Report FL #: 10088 for Greenheck models EHH-601D & ESD-635D (both w/ and w/o VCD-40 Damper)

Report FL #: 10093 for Airolite models SCH601MD & K6746MD (both w/ and w/o VCD-40 Damper)

NOTICE OF ACCEPTANCE (NOA)

APPROVAL DOCUMENT: Drawing No. **EHH-601D**, titled "EHH-601D Louver", sheets 1 through 35 of 35, dated 08/09/2017, prepared by Greenheck Fan Corporation, signed and sealed by Wayne K. Helmila, P.E. on 09/27/2024, bearing the Miami-Dade County Product Control revision stamp with the Notice of Acceptance number and expiration date by the Miami-Dade County Product Control Section.

DRAWN BY MES	DATE 8/9/2017	SHEET NO. 29 OF 35	CAD DRAWING NO. EHH-601D
SCALE			
GREENHECK P.O. BOX 410 SCHOFIELD, WISCONSIN 54476-0410		TITLE EHH-601D LOUVER CONTINUOUS ANGLE MOUNT MULLION END PLATE LAYOUTS HS144" & HS96"

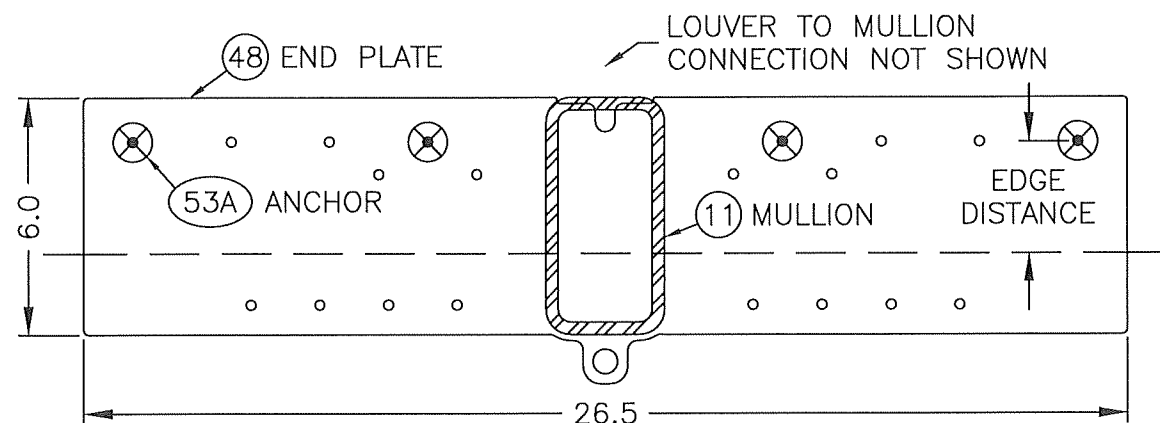
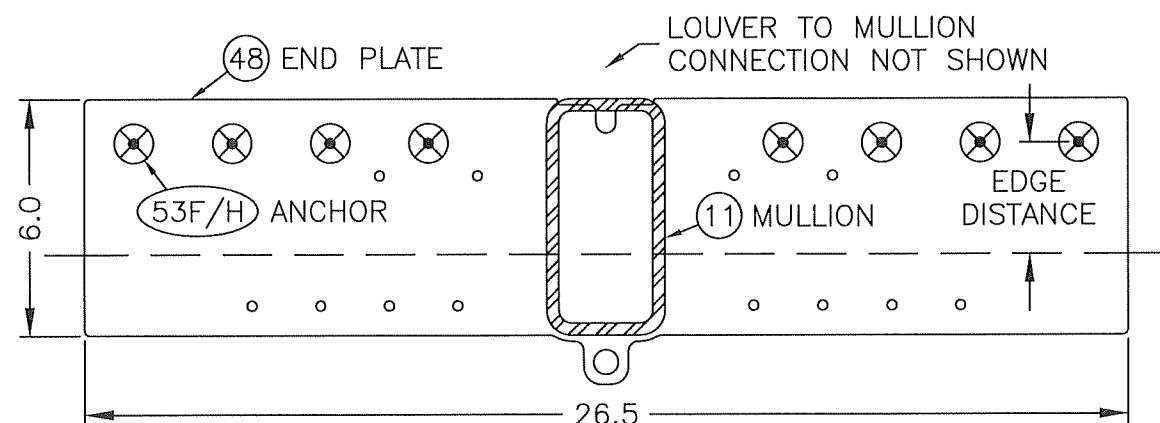
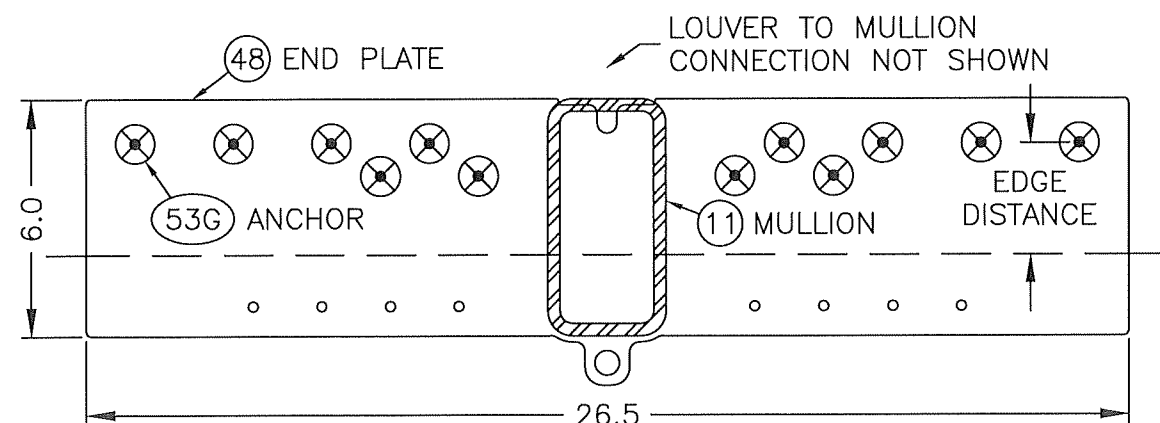
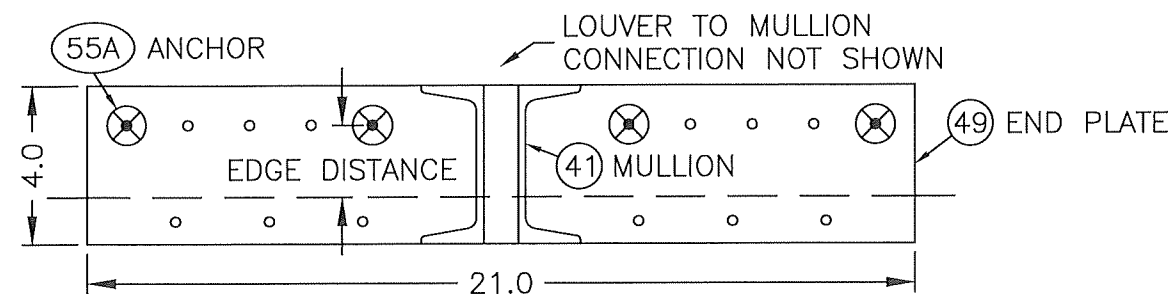
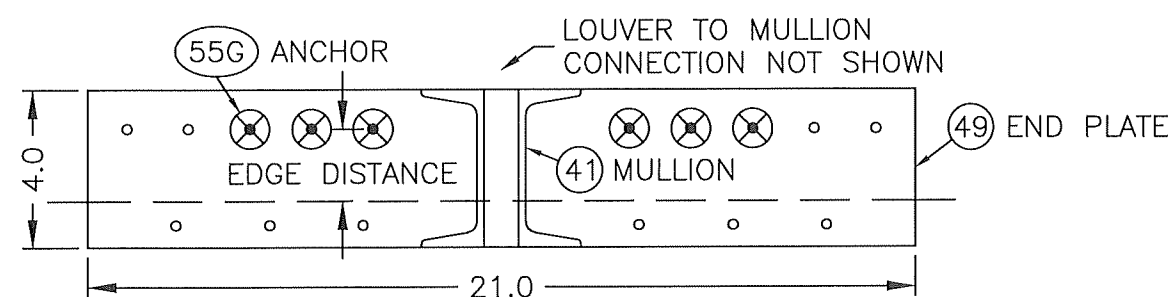
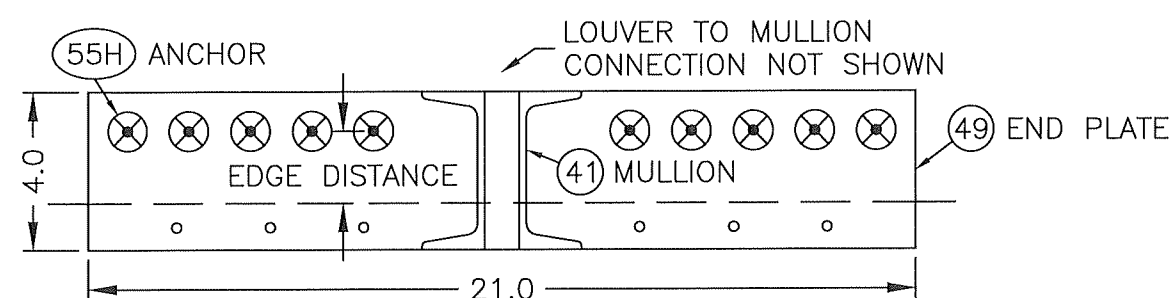
REV 01: 8/1/24, NEW PAGE TO SHOW VARIOUS SUBSTRATE ANCHOR LAYOUTS.
